**PROPOSED MODIFICATION TO THE NORTHERN EXTENSION
LANDFILL AT EASTERN CREEK WASTE & RECYCLING CENTRE**

**ENVIRONMENTAL ASSESSMENT
SUBMISSIONS REPORT**

**EC2 Cell 5 EA – Tributary diversion concept design
Modification Application to Ministerial Consent No. DA271-6-2003-I MOD 4 for Eastern Creek Waste and Recycling Centre located off Wallgrove Road, Eastern Creek.**

EASTERN CREEK LANDFILL - NORTHERN CELLS	
STREAM DIVERSION CHANNEL TYPICAL SECTIONS MODIFICATIONS REMOVE ONE PIPE	
SKETCH	20010705-SK-029

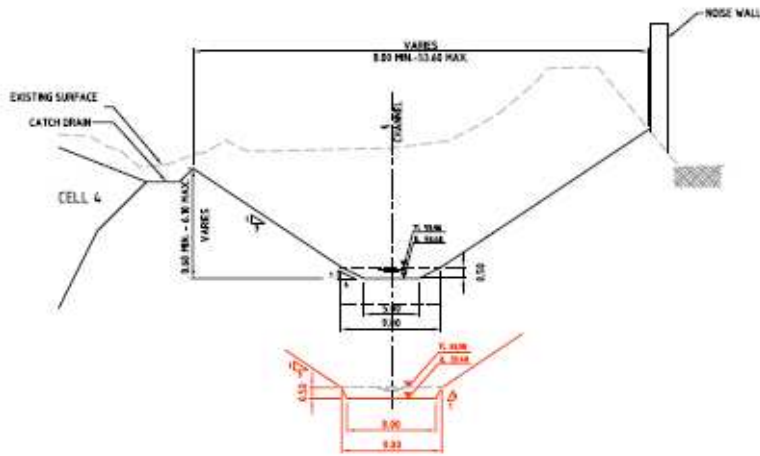
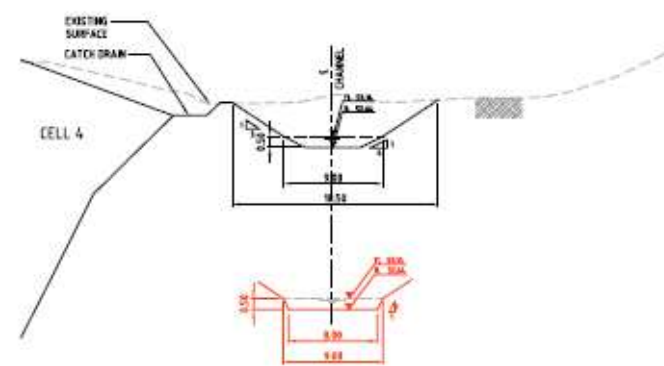
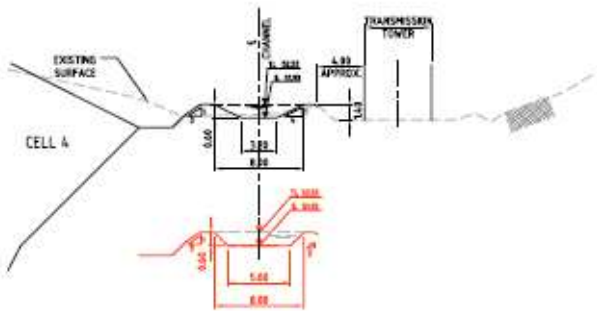
Council's response includes suggestions requiring the creek diversion design to include frequent low flow replenishment to the diversion creek by removing one or both of the low flow pipes from the system. This letter includes discussion of the following points:

Sketches of these new cross sections are attached, see "Modifications Remove One Pipe" and the changes are summarised in the following table.

Batter slopes do not need to be as steep as for removing both pipes, however slopes of 1 in 2 and steeper will be subject to erosion in a naturalised creek and the channel would need to be changed to a more engineered type. Also steeper sides will provide further risk to site safety and may cause potential problems for Integral Energy access.

EASTERN CREEK LANDFILL - NORTHERN CELLS	
STREAM DIVERSION CHANNEL TYPICAL SECTIONS MODIFICATIONS REMOVE BOTH PIPES	
File: SKETCH	Date: 20010705-SK-028

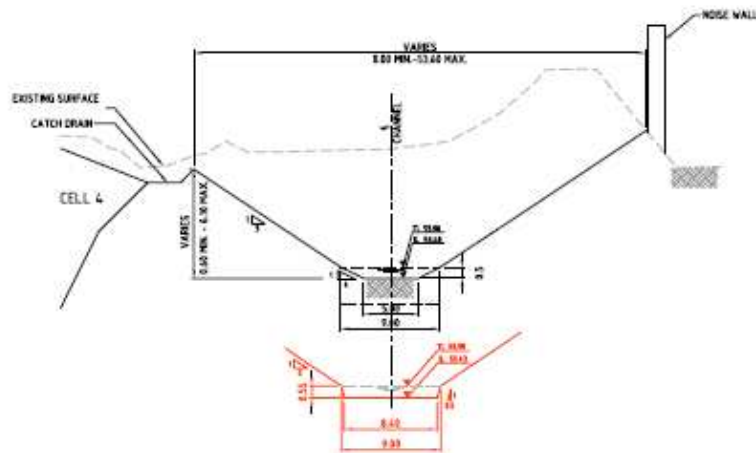
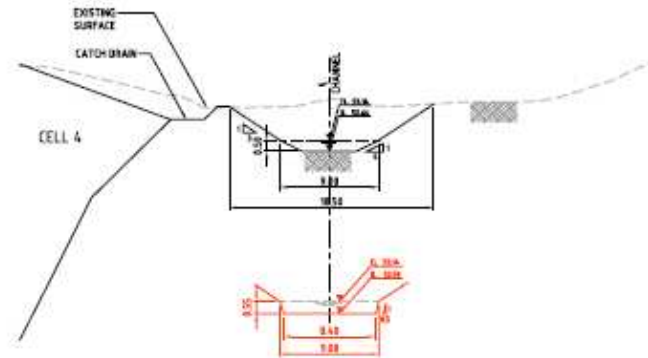
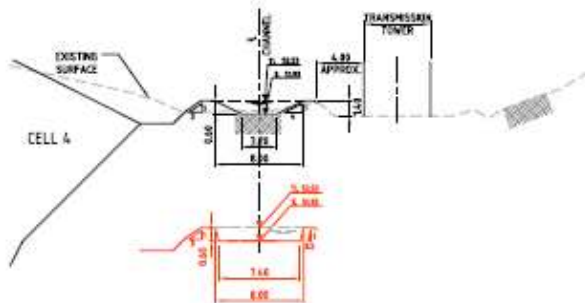
If both pipes are removed from the system, it is required that the entire 100 year ARI storm be contained within the diversion creek. New channel cross-sections at section 1, 2 and 3 were calculated to demonstrate this change. The channel invert levels at those sections had to remain close to the current levels to retain grades to Eastern Creek. (Refer to point 5 in section 1.0) Therefore the maximum depth of water in those sections had to remain close to the current. The overall width of the channel had to also remain the same. (Refer to points 1 to 4 in section 1.0).

Refer to the attached hand sketches on "Modifications Remove Both Pipes" for changes to each of the channel sections to achieve the required capacity. These changes are summarised in the following table.

The depth has slightly increased at section 1 and 2 but the significant change to the channel section is the steeper batter slopes.

Batter slopes of 1 in 0.5 will not have adequate protection against erosion in a natural or vegetated channel. In order to prevent erosion the channel would need to change to a more engineered/less ecologically sustainable type, such as concrete, to achieve increase in channel capacity.
